**Response to Comments
on
EPA Draft 2020 Permit Modification to the 2016 Reissued RCRA Permit and
Associated Statement of Basis for EPA’s Remedial Action for the “Rest of River”
Portion of the Housatonic River**

GE-Pittsfield/Housatonic River Site

December 2020

U.S. Environmental Protection Agency
Region 1 (EPA New England)

FIGURE 6

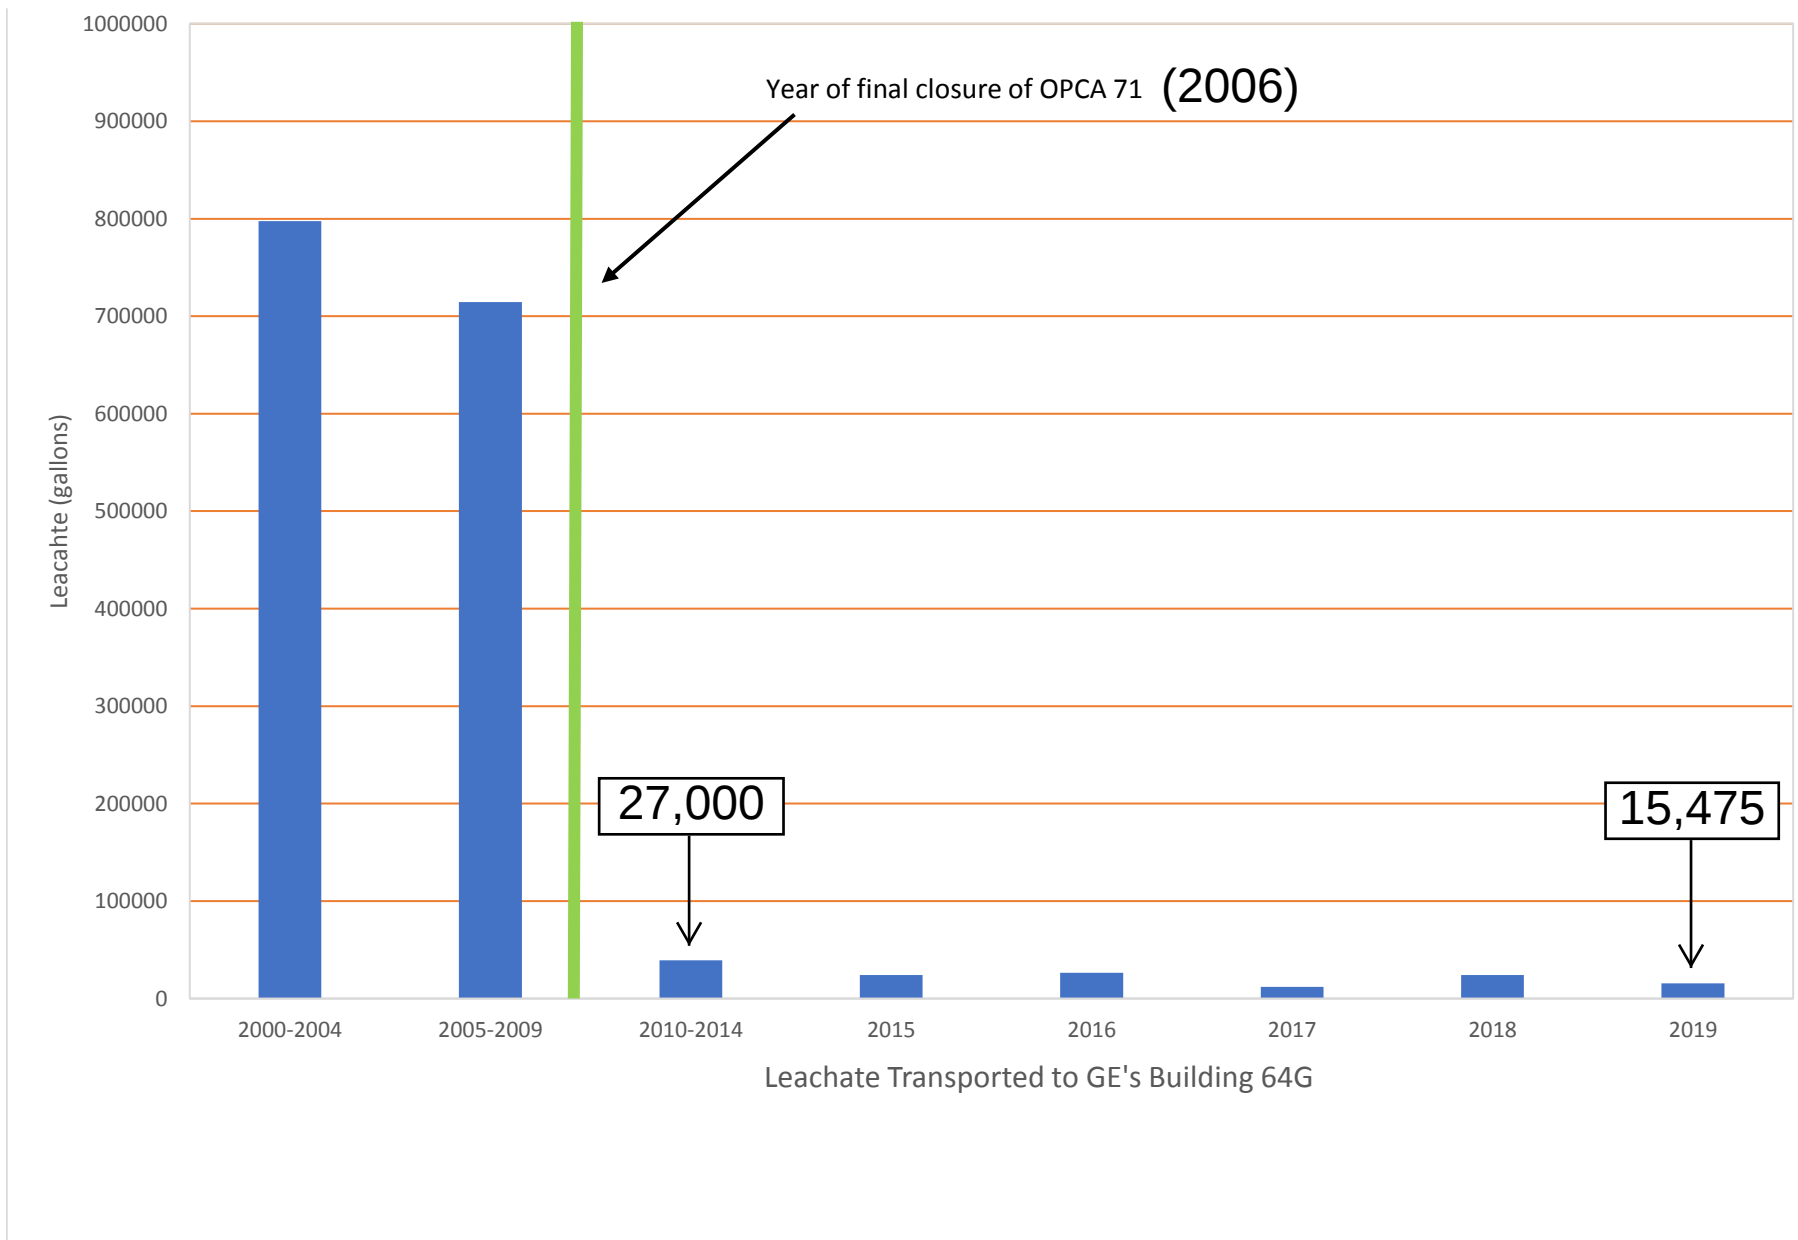
Comment II.A.3: Several commenters expressed concerns that the proposed UDF is similar to the landfills/OPCAs constructed in Pittsfield as part of the Consent Decree and that in the commenters’ view, the landfills/OPCAs are leaking or are otherwise not safe.

The Building 71 OPCA has a single bottom liner and a leachate collection system. Prior to closure of the Building 71 OPCA, approximately 75,000 gallons of leachate were collected. After closure, the volume of leachate collected has steadily decreased from 27,000 gallons to 15,475 gallons per year. Figure 6.

**FIGURE 7
SURFACE WATER ELEVATIONS
AND WATERSHED SUBBASINS**

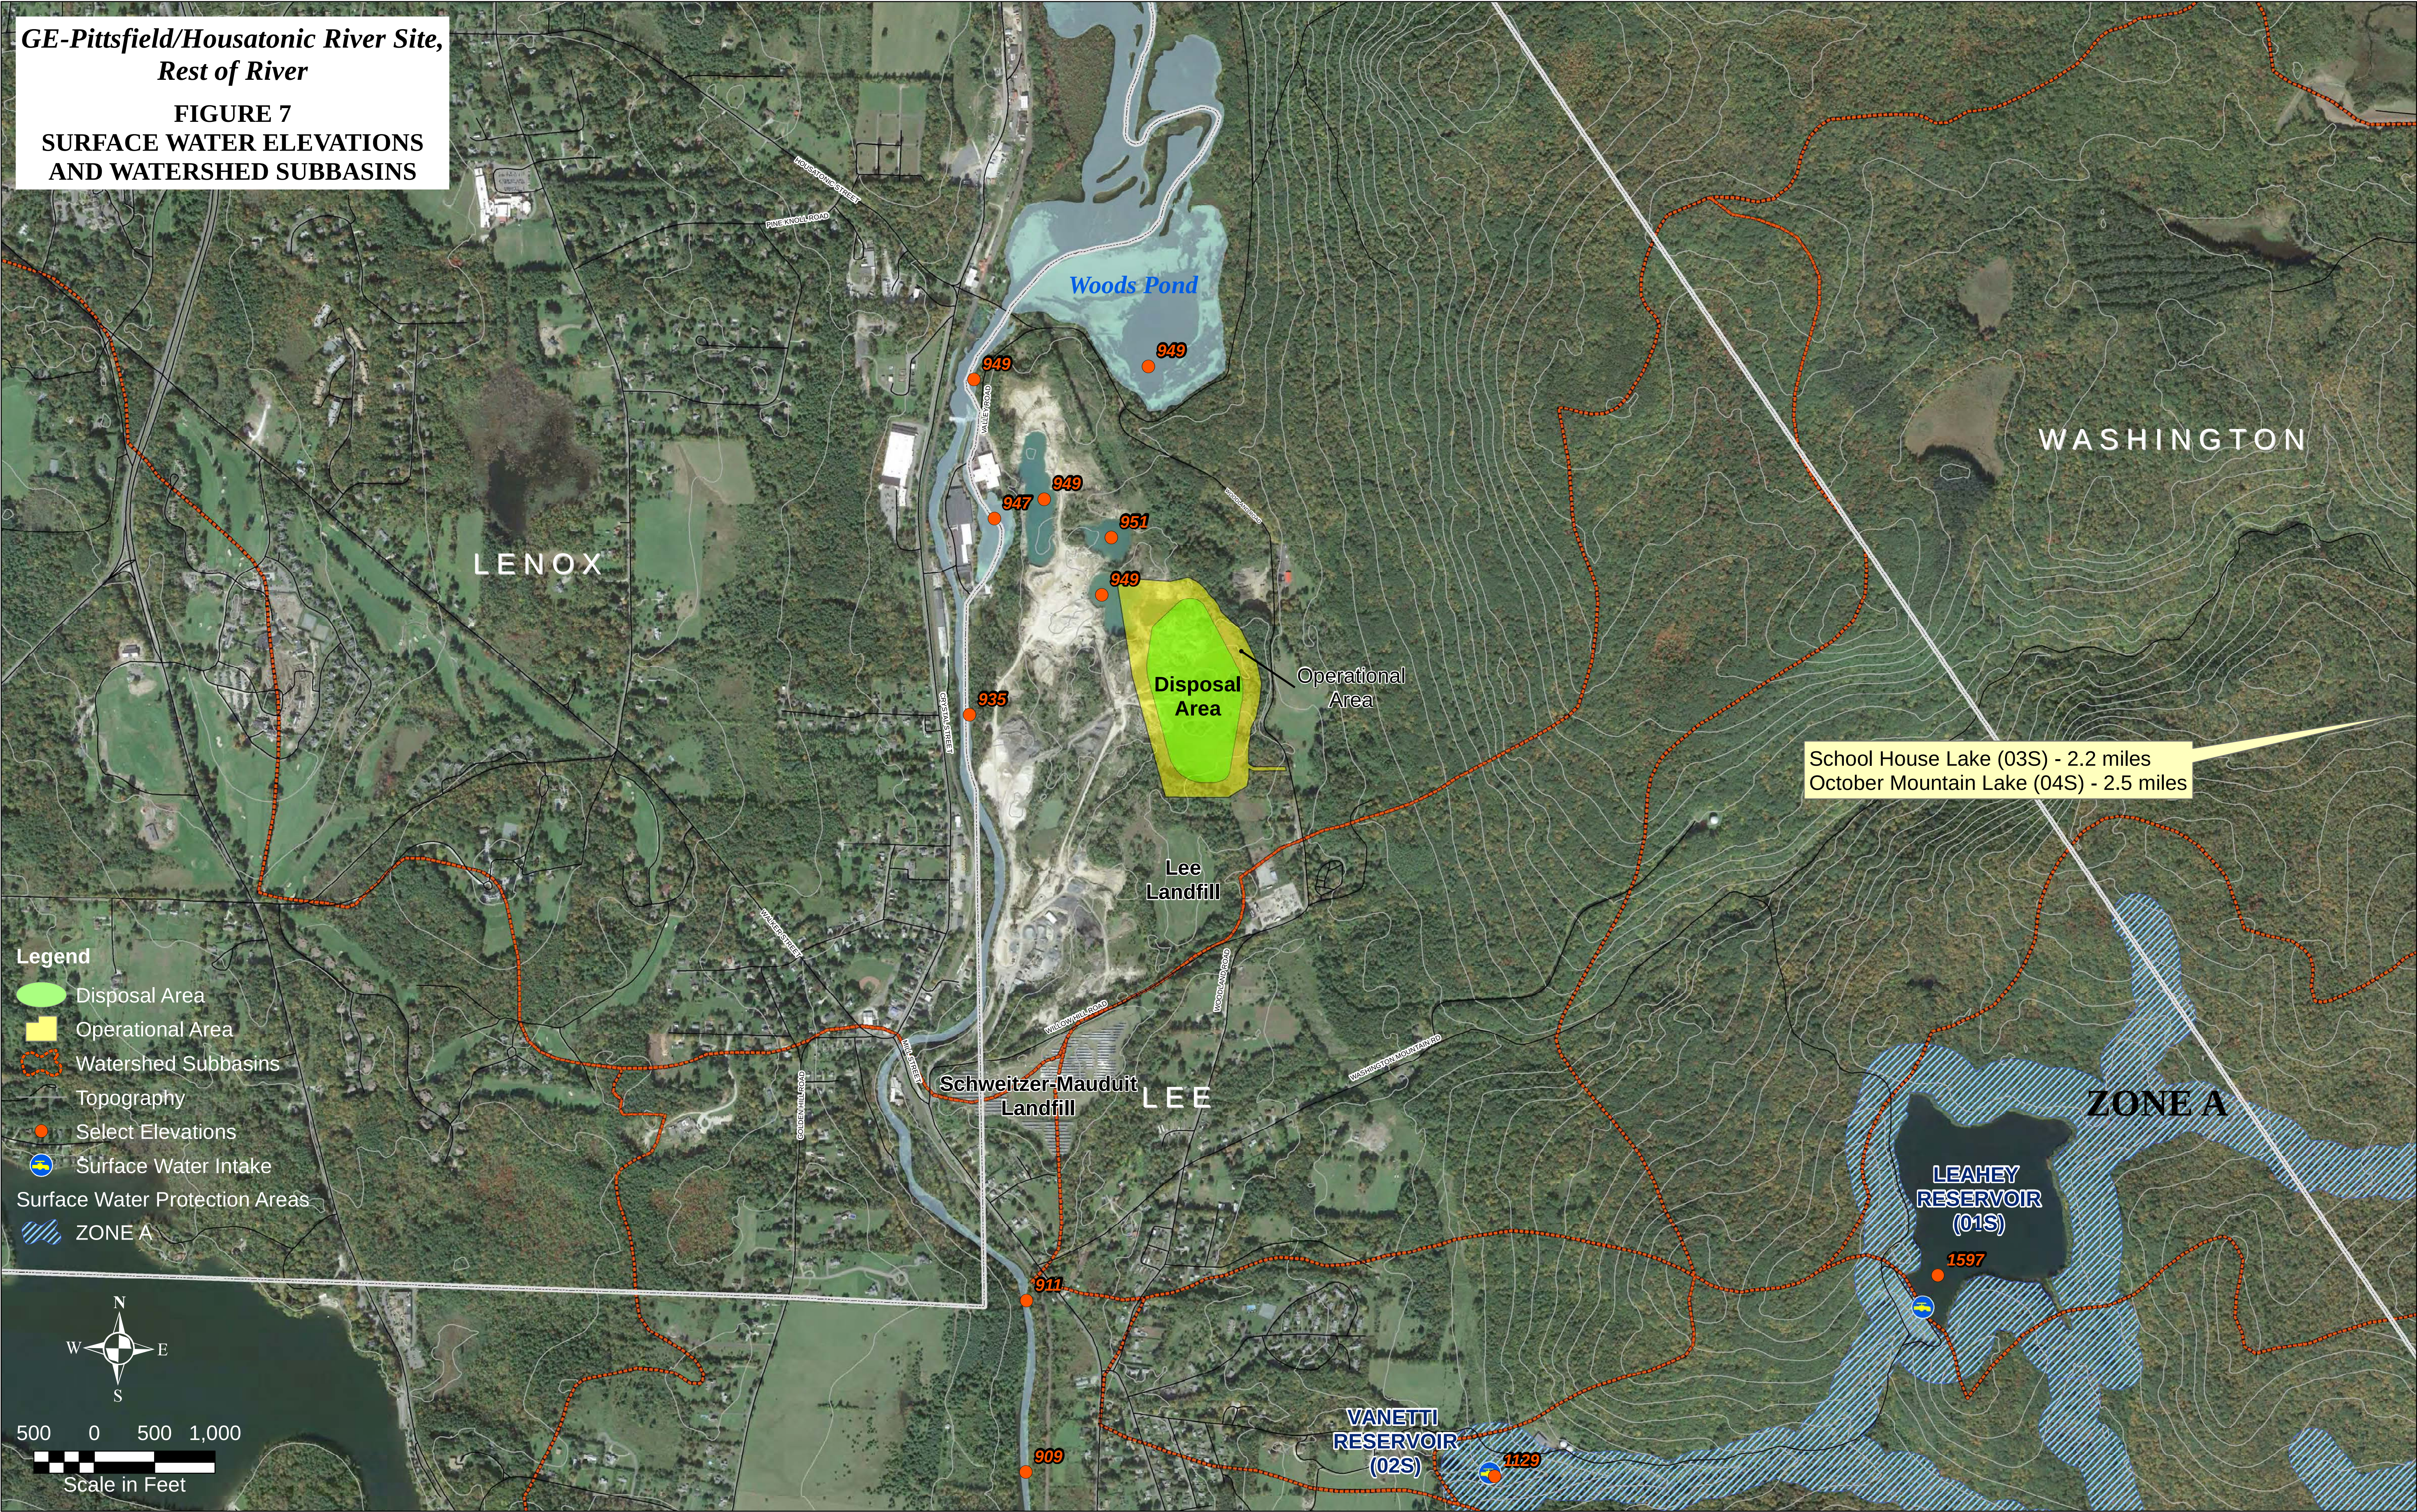
Comment II.A.5: Several commenters expressed concerns about impacts to local water supplies should a release occur. A number of commenters questioned the provisions for abandonment of

reservoirs. 2018 *Post-Closure Environmental Monitoring Report*, Schweitzer-Mauduit International, Inc. Willow Hill Road Landfill, C.T. Male Associates to DEP, June 11, 2018; CDM figure titled “Town of Lee Sanitary Landfill, Bedrock and Overburden Contours, January 30, 1995.” Figure 9. In addition, based on surface water elevations, the expected groundwater flow is generally east to west—from the UDF towards the Housatonic River, and similarly, from the Town of Lee reservoirs westerly towards the River. Figure 7.
